Office Action Summary	Application No. 09/706,667	Applicant(s) JANSEN VAN DOORN, ARNOLD KAREL	
	Examiner David C. Payne	Art Unit 2633

DETAILED ACTION***Response to Arguments***

Fig. 1

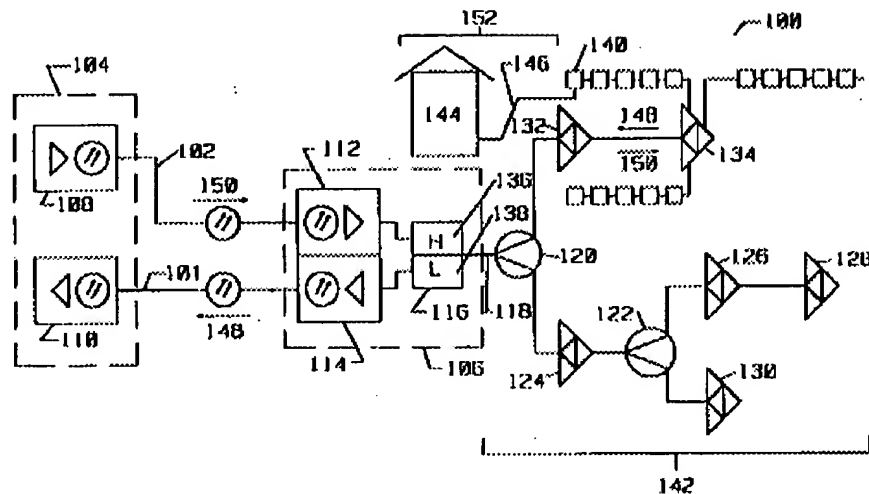
Williams disclose a system for characterizing undesirable noise in an optical cable system (Figure 1). Williams further disclosed a filter (116 of Figure 1) in front of an optical transmitter (108 of Figure 1). This filter being necessary to protect a transmitter from impairments (col./line: 4/2-13) from the test scenario of impulse noise (see e.g., col./line: 10/67, 11/1) that demonstrates clipping at the transmitter (see e.g., col./line: 10/40-45). Williams further disclosed a noise detector (or trigger circuit col./line: 6/35-45).

Williams disclosed wherein this filter (116 of Figure 1, col./line: 4/25-30) is arranged in terms of a high pass filter (136 of Figure 1) and/or a low pass filter (138 of Figure 1). It would have been obvious to one of ordinary skill in the art at the time of invention to arrange the Chen filters in this fashion in order to filter out the noise burst that typically occur between 5 and 15 Mhz as disclosed in Williams (col./line: 2/1-5). Furthermore, the high-pass and low-pass filters operate to pass signals in the downstream ranges 54 to 550 MHz (see Williams col./line: 1/32-35) and the upstream ranges 5 to 30 MHz (Williams col./line: 1/49-50).
